ArevaEPRDCPEm Resource

From: WILLIFORD Dennis (AREVA) [Dennis.Williford@areva.com]
Sent: Thursday, July 14, 2011 10:24 AM
To: Tesfaye, Getachew
Cc: BENNETT Kathy (AREVA); DELANO Karen (AREVA); ROMINE Judy (AREVA); RYAN Tom (AREVA); Miernicki, Michael
Subject: Response to U.S. EPR Design Certification Application RAI No. 354, FSAR Ch. 3, Supplement 27
Attachments: RAI 354 Supplement 27 Response US EPR DC.pdf

Response to Question 03.08.02-13:

Figure 03.08.02-13-1—Eigen Value Buckling Mode

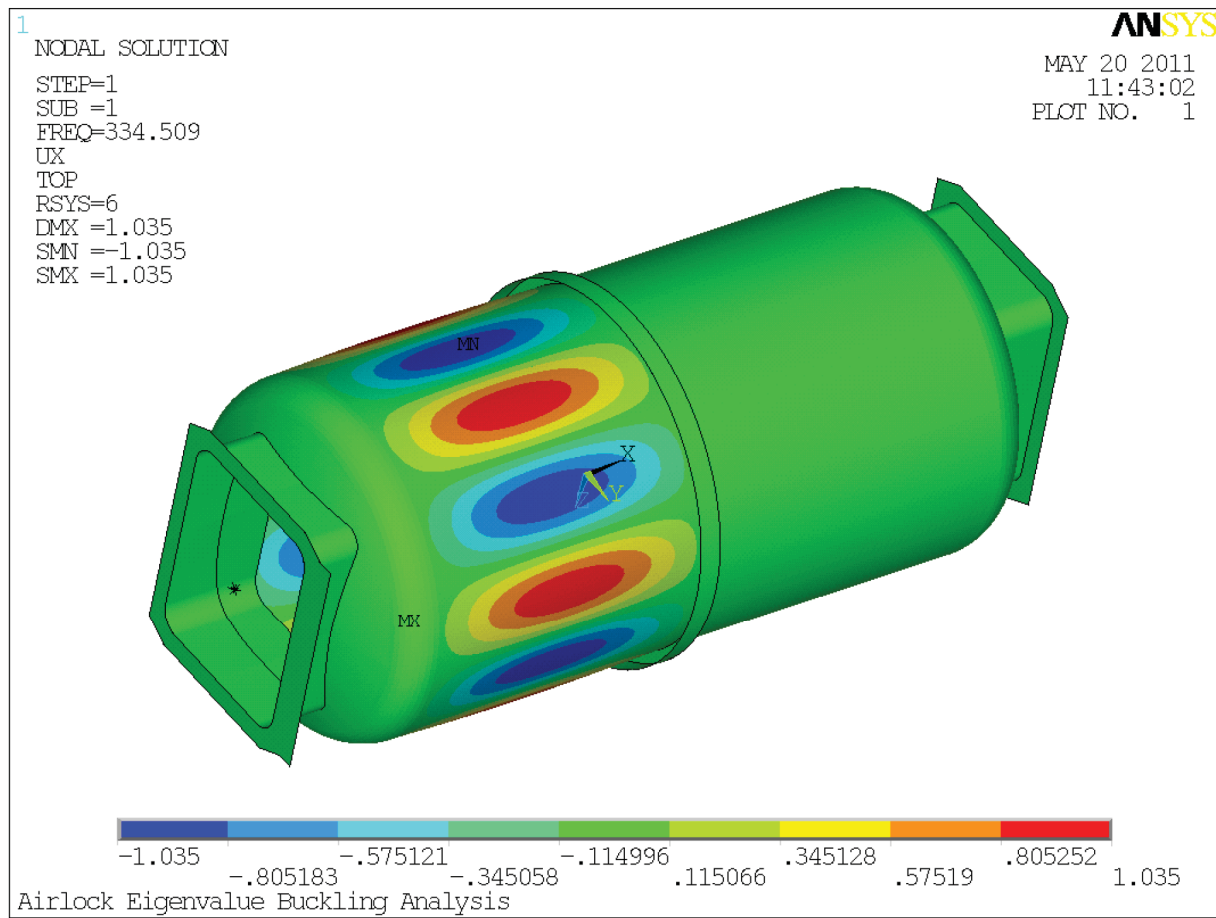
- a) Based on the linear Eigen value buckling analysis results – the initial geometric imperfection was considered to be 1 percent of the Eigen value buckling mode shape, or 0.527 mm. This 1 percent buckling mode shape is the initial geometry for the rigorous nonlinear buckling analysis previously described (see Figure 03.08.02-13 -1).

Figure 03.08.02-13-2—Ovalized Cylinder

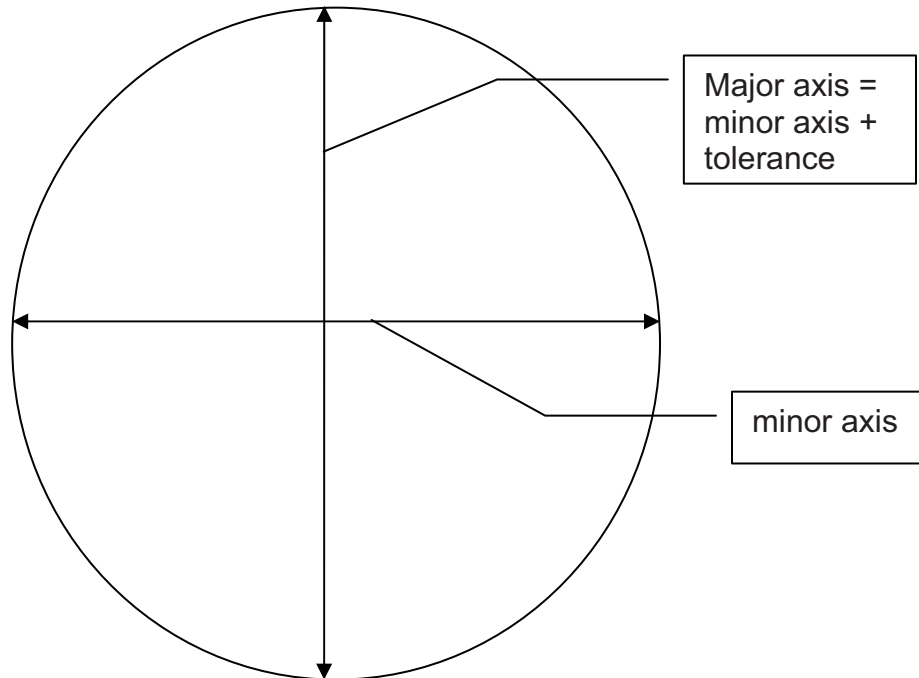
- b) Based on an ovalized cylinder that considers the tolerances of the assembly – the initial geometric imperfection was considered to be an ovalized cylinder with the difference in the major and minor diameter equaling the tolerance; 2 mm (see Figure 03.08.02-13 -2). An initial imperfection of 31 mm has also been modeled based on ASME Subsection NE, Paragraph 4221.1. The critical buckling pressure was reduced by approximately 3 psi or about one percent. The critical buckling pressure of the personnel airlock cylinder is therefore relatively insensitive to the size of the initial assumed imperfection.
